Referral 8: Moorabbin Activity Centre

Activity Centres Standing Advisory Committee Report

12 November 2024

Figure 1 Moorabbin Activity Centre – regional context (left) and extent of the Activity Centre and catchment (right)

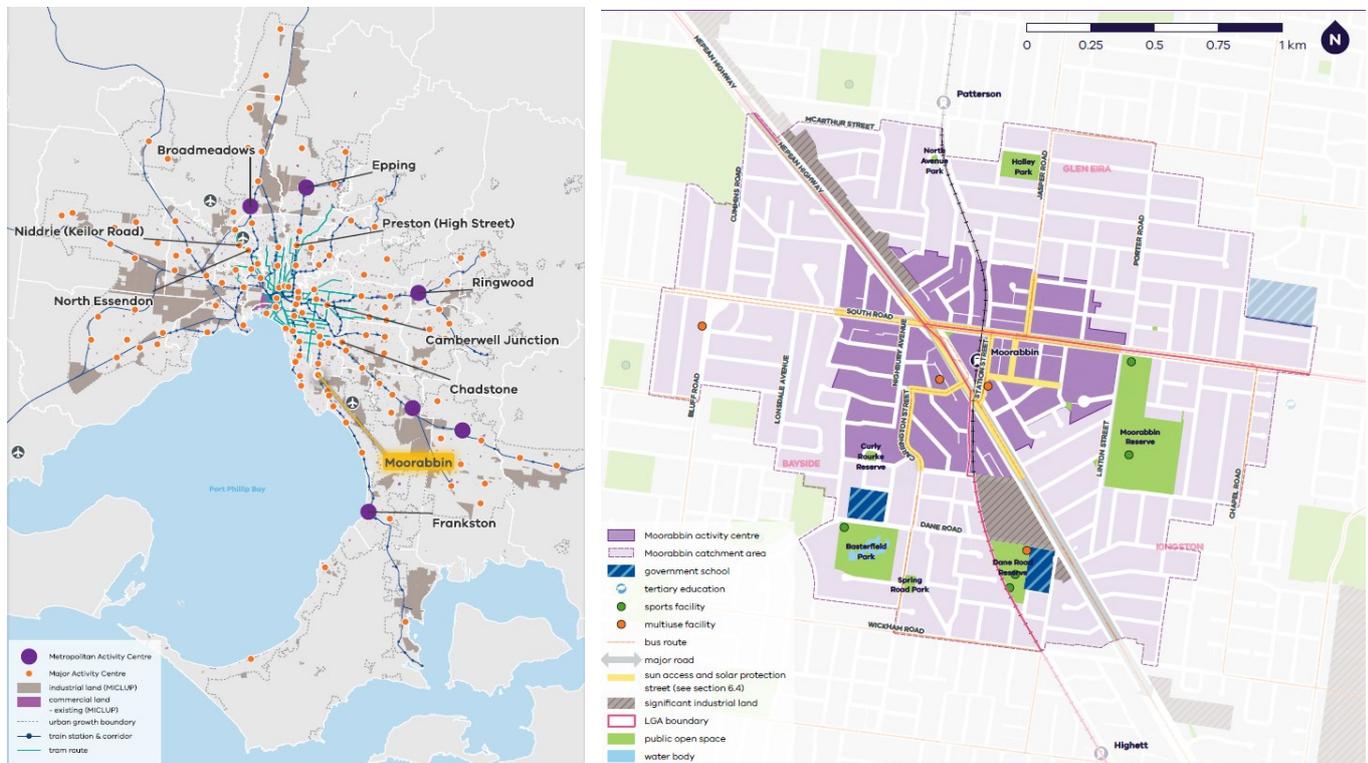
The Moorabbin Activity Centre (the Activity Centre) is located around 18 kilometres from the Melbourne Central City. The Activity Centre is shown in dark purple in Figure 1 (right image). The walkable catchment is shown in light purple.
